SUNDRY NOTICES AND REPORTS ON WELLS (DO NOT USE THIS FORM FOR PROPOSALS TO DRILL OR TO DEEPEN OR PLUG BACK TO A DIFFERENT RESERVOIR. USE "APPLICATION FOR PERMIT" (FORM C-101) FOR SUCH PROPOSALS.)		WELL API NO. 30-005-61733

2. Name of Operator Vanguard Operating LLC		6. State Oil & Gas Lease No.
3. Address of Operator 5847 San Felipe St., Suite 3000, Houston, TX 77057		7. Lease Name or Unit Agreement Name IRIS STATE

LEASE/WELL: IRIS STATE #3
 LOCATION 660' FSL & 1,980' FEL
 O-SEC 21-T07S-R23E
 CO/ST: CHAVES COUNTY, NEW MEXICO
 FIELD: PECOS SLOPE; ABO, WEST
 API NO. 30-005-61733

CONDITIONS FOR PLUGGING AND ABANDONMENT

AFTER RPA

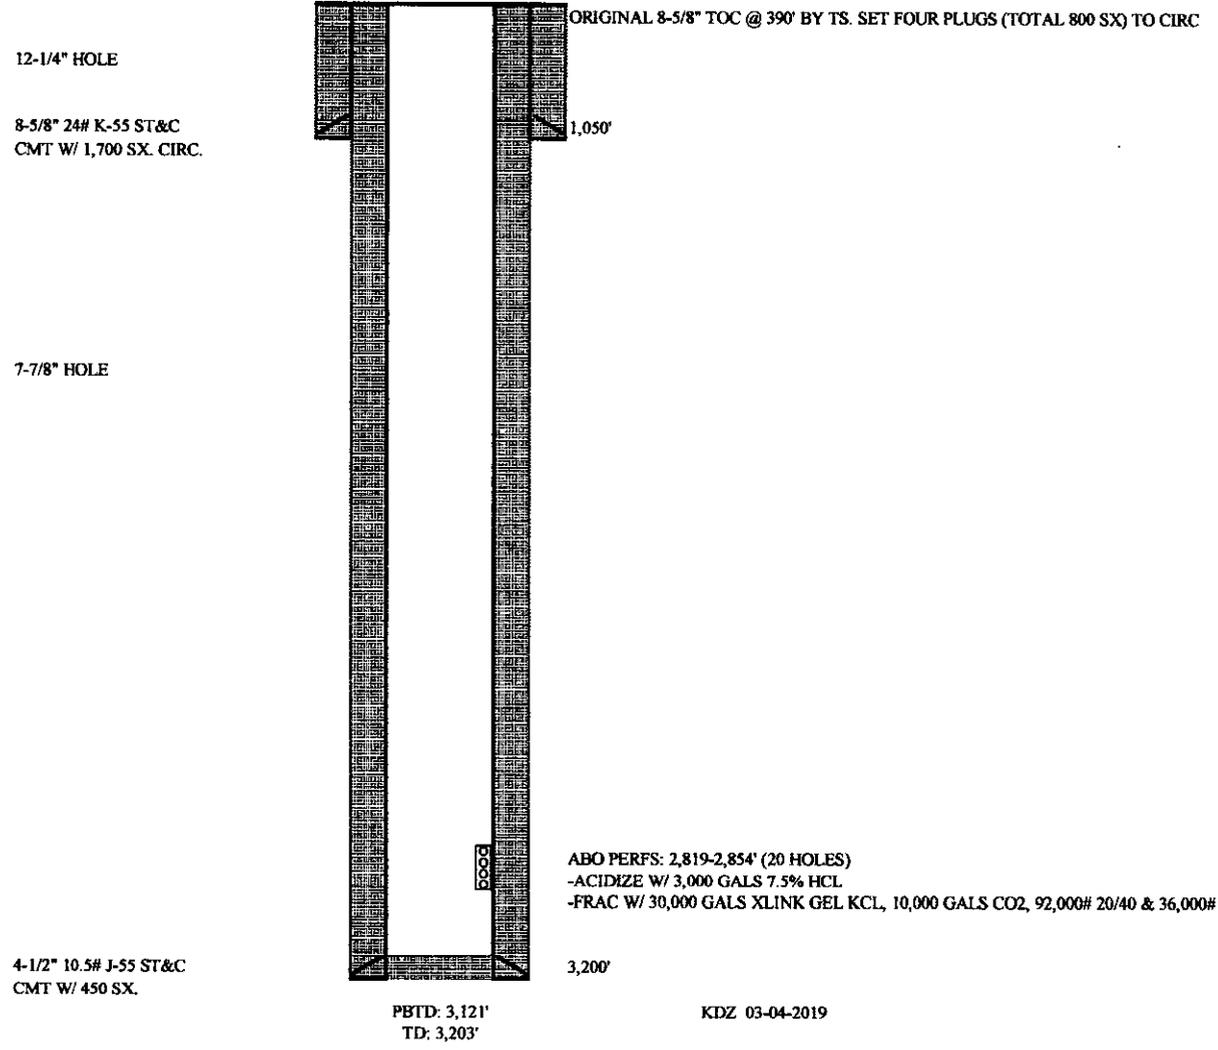
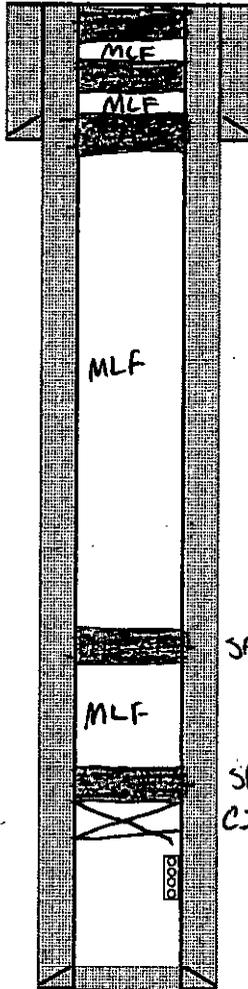
1. Notify OCD 24 hrs prior to MIRU to P&A.
2. Set CIBP @ 2769', RIH w/tbg, tag CIBP, circ hole with MLF, test csg and CIBP.
3. Spot 25 sx's cmt @ 2769'-2669'. - WOC + Tag
4. Spot 25 sx's cmt @ 2154'-2054' (TUBB).
5. Spot 25 sx's cmt @ 1100'-1000' (SHOE) WOC & TAG. - Perf @ 1100' + Attempt to Circ.
6. Spot 75 sx's cmt @ 754'-420' (YESO) (GLORIETA).
7. Spot 25 sx's cmt @ 100', circ to surface. - Perf @ 100' + Attempt to Circ.
8. Cutoff wellhead and anchors, install dry hole marker & move off.

* See Attached COA's Must be Plugged by 3/13/20
